Pacific Gas and Electric Company

PG&E Letter DCL-00-116

Docket No. 50-275, OL-DPR-80
Docket No. 50-323, OL-DPR-82
Diablo Canyon Units 1 and 2
Emergency Plan Implementing Procedure Update

On-The-Spot-Change

FIGURE 1b

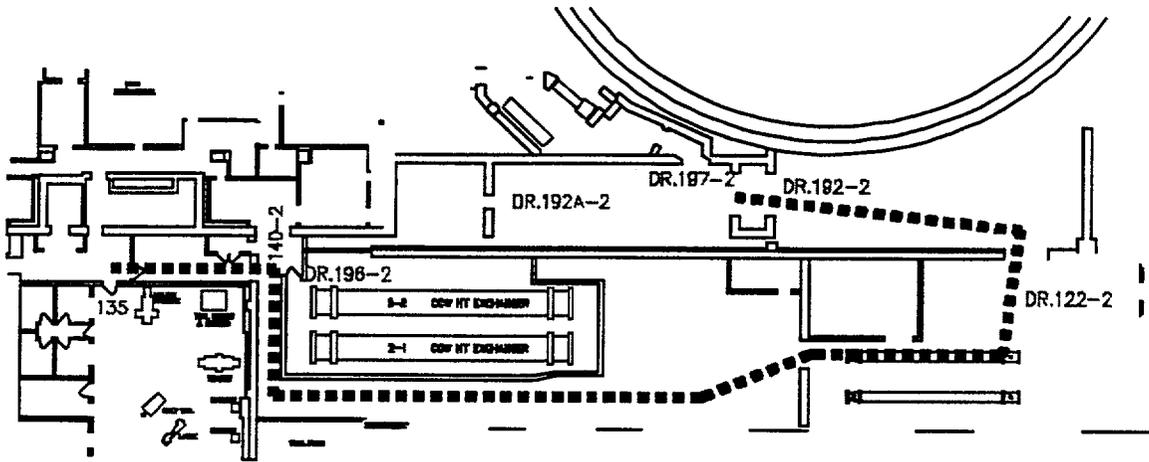
Starting at the Cold Machine Shop proceed into the hallway to door #140, proceed south to door #122 and exit building. From here turn north and enter door #122 to the Motor Repair Shop.

FIGURE 2b

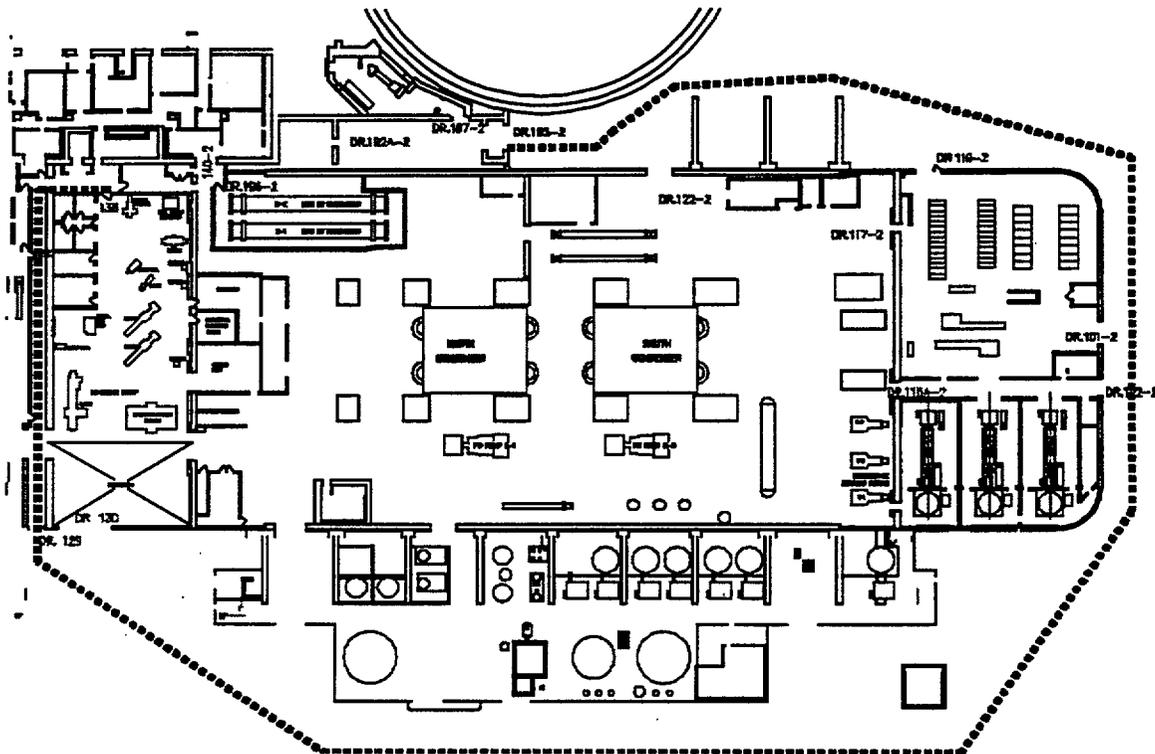
Starting at the Cold Machine Shop proceed to the outside via door #129, turn left and continue south around the Unit 2 Turbine Building looping around the transformers at the south end of the plant. Continue north to door #192 between containment and the Turbine Building. Enter the Motor Repair Shop via door #~~192~~ *192-2.*
